MINUTES  
DEVELOPMENT REVIEW COMMITTEE  
MEETING OF SEPTEMBER 8, 1997

**8-98001      CLARKSBURG TOWN CENTER**

RE: Site Plan No. 8-98001  
Clarksburg Town Center, Phase I

RE: Site Plan #8-98001  
Clarksburg Town Center - Phase I

# MID-COUNTY ARTERIAL, (A-305)

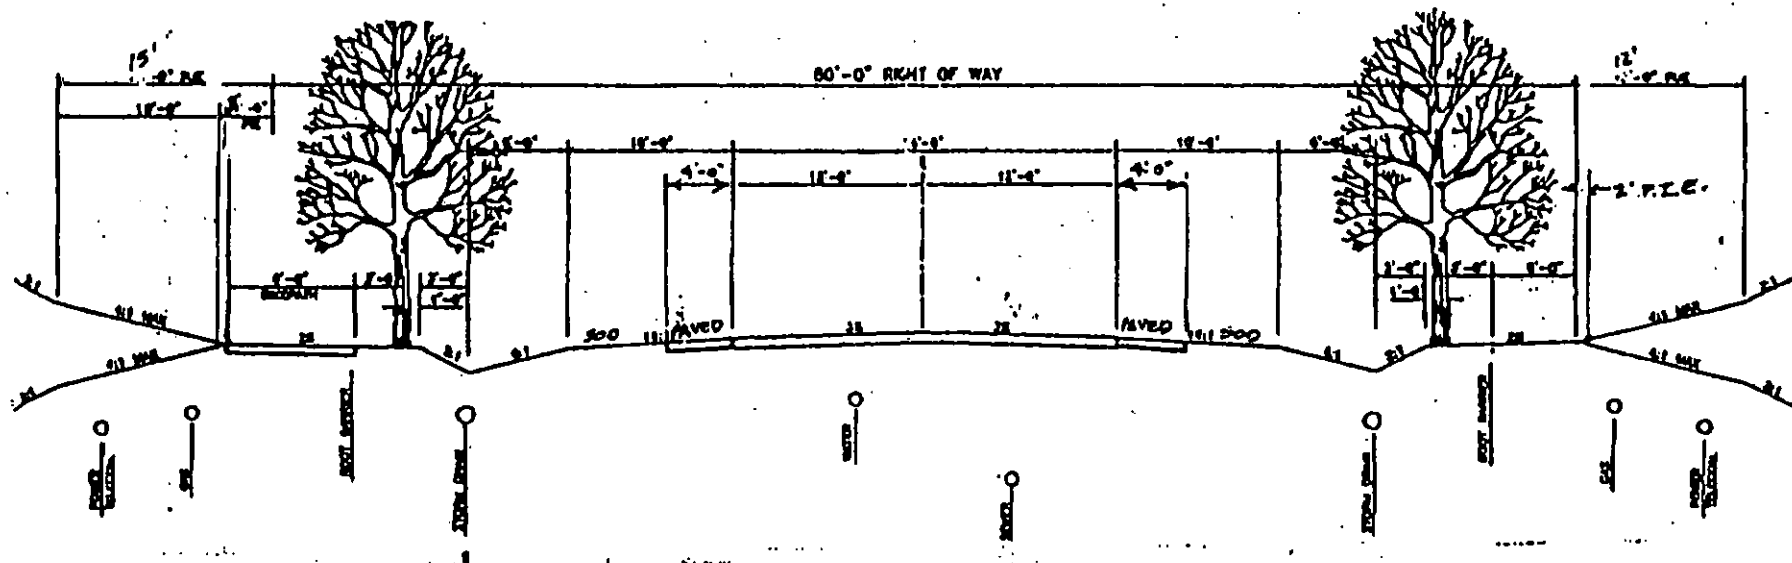
This roadway should be constructed as a two-lane open section roadway within an eighty (80) foot wide right of way as shown on the enclosed red-lined typical section (Enclosure No. 2). In order to accommodate the master planned Class I bikepath along the Town Center site frontage, the applicant will need to modify the standard typical section to provide an eight (8) foot wide Public Improvements Easement and an overlapping eighteen (18) foot wide Public Utilities Easement. The Class I bikepath and street trees along this roadway are to be located behind the side ditch. As agreed during our staff discussions, a sidewalk will not be required along the east side of this roadway.

STRINGTOWN ROAD (A-260)  
(MID-COUNTY HIGHWAY (A-305) TO STREET "C")

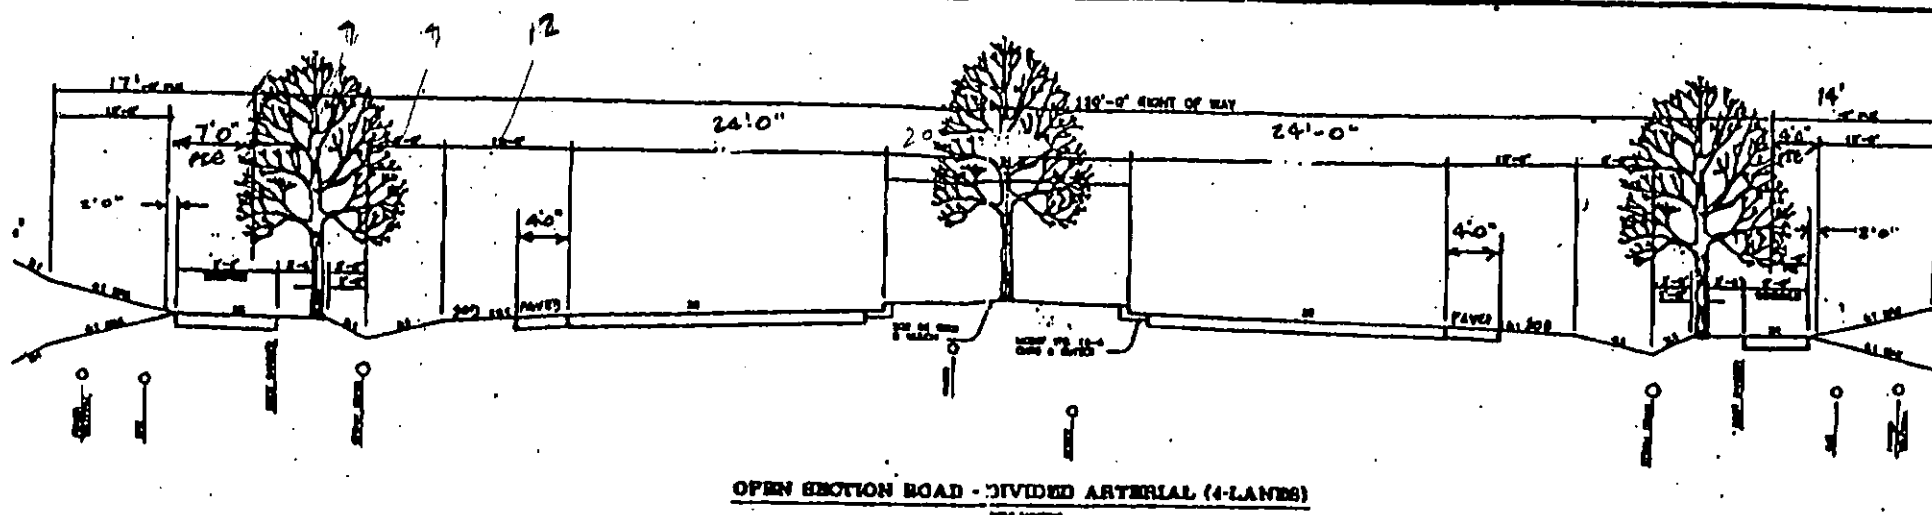
As reflected on the attached drawing (Enclosure No. 4), Stringtown Road shall be a hybrid design (closed section median with an open section design on the outside) between Street "C" and Mid-County Arterial (A-305). The median width will be twenty (20) feet. The pavement width will be twenty four (24) feet with a four (4) foot wide paved shoulder. Street trees and the master planned Class I bikepath will be located behind the side ditch.

STRINGTOWN RD (A-260)  
(BETWEEN MD 355 & STREET "K" (THE "GREENWAY" ROAD))

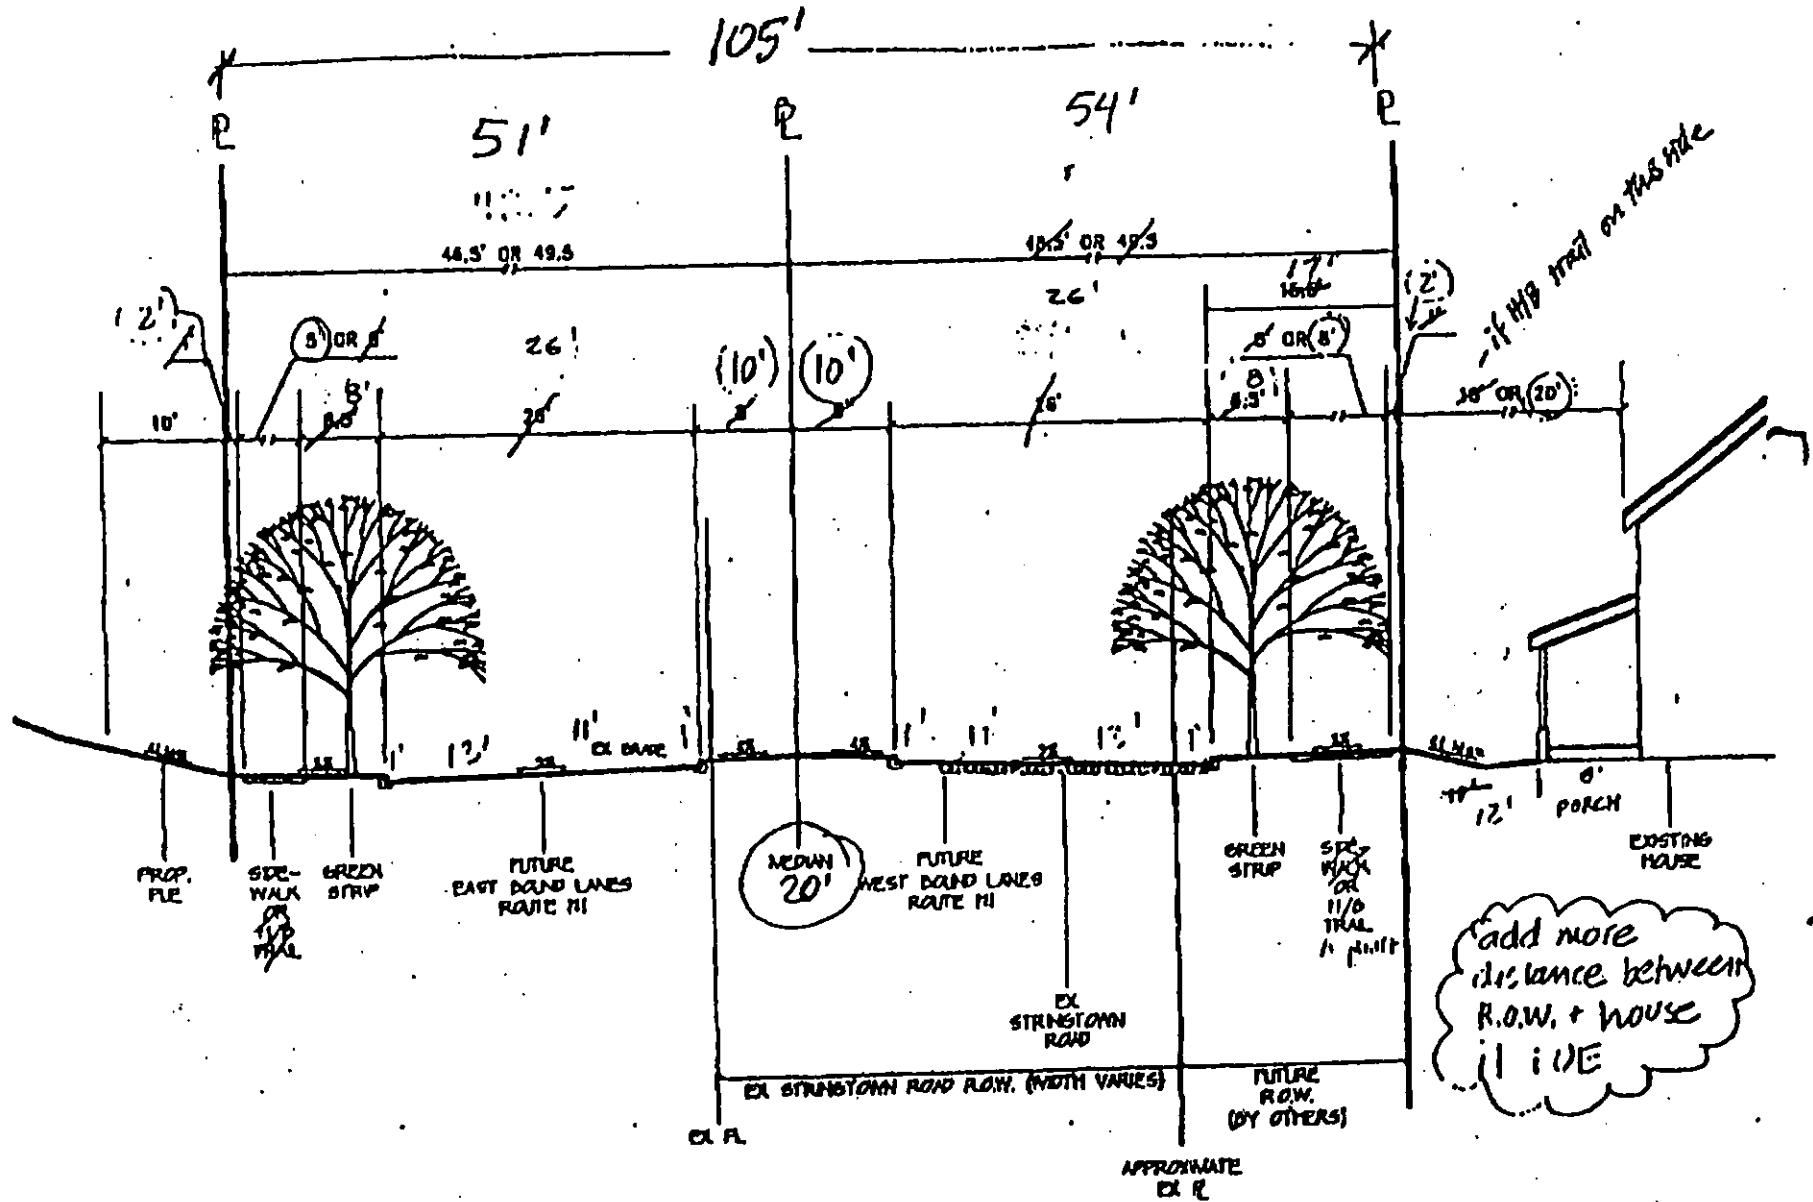
Between Frederick Road (MD 355) and Street "K," the right of way may be reduced to one hundred (105) feet and the roadway constructed entirely closed section in an effort to minimize the impact on the nearby historic district. As noted on the enclosed drawing (Enclosure No. 3), the pavement shall be twenty six (26) feet wide with a twenty (20) foot wide median.

# CLARKSBURG TOWN CENTER PARK / SCHOOL CONCEPT PLAN CLARKSBURG, MD 20871

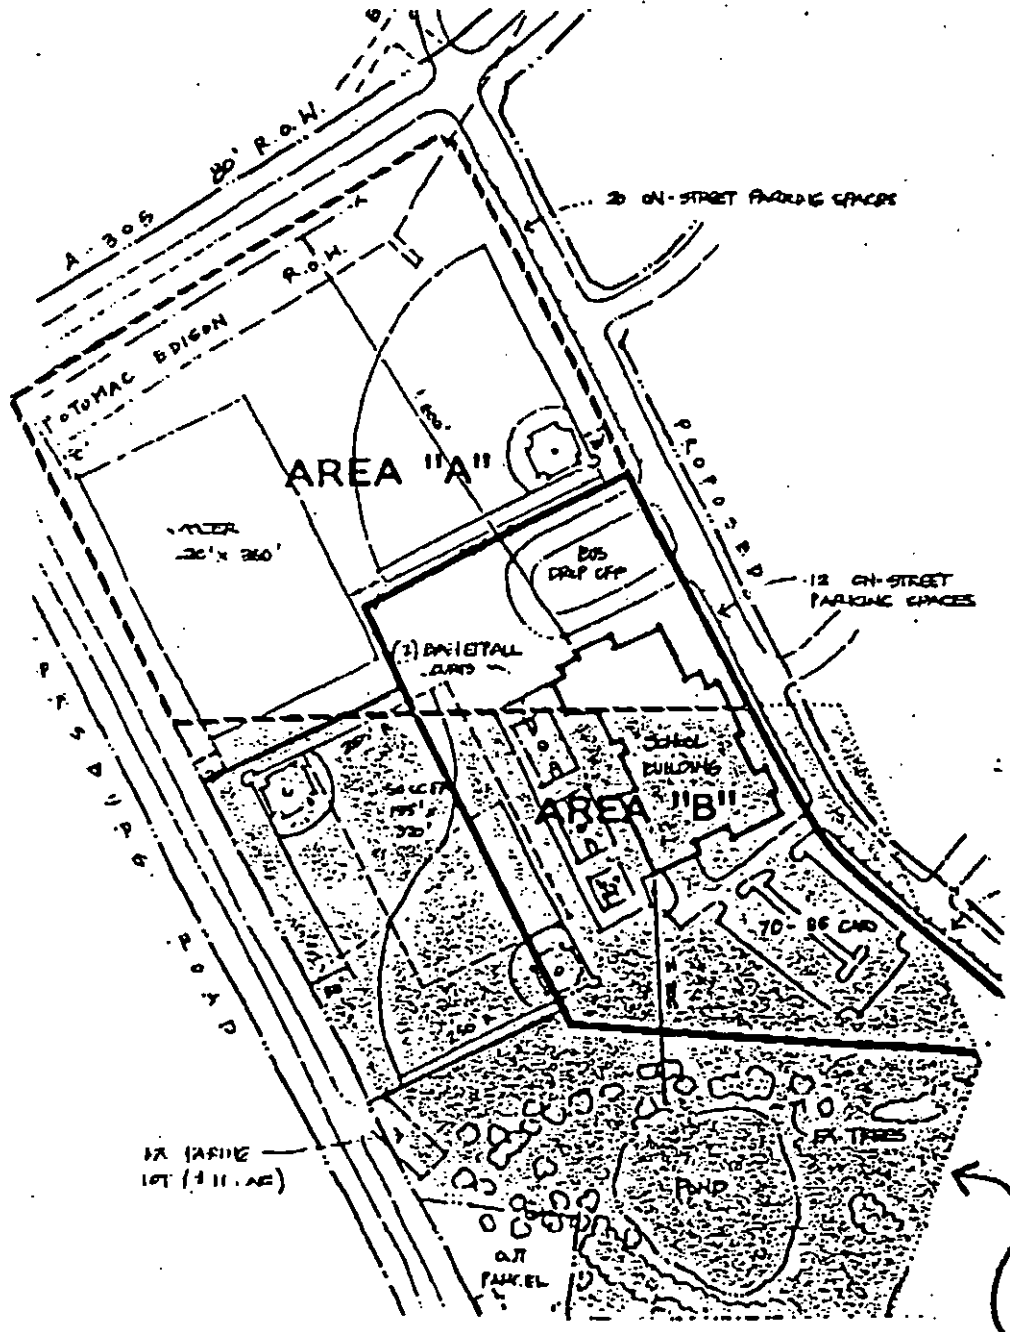
MCPS continues to prefer that the land dedication be made directly to the Board of Education. I am again requesting that this 8-acre parcel be deeded directly to the Board of Education by the developer following the usual procedures for subdivision approval and recordation of a plat for the site. This land is being provided solely for school purposes and as such should be titled to the Board of Education. At such time as the Board of Education's Capital Improvements Program is funded for a school to be constructed here, Parks Division can exchange this 8-acre parcel for another 8-acre parcel within the site as shown on the enclosed exhibit.
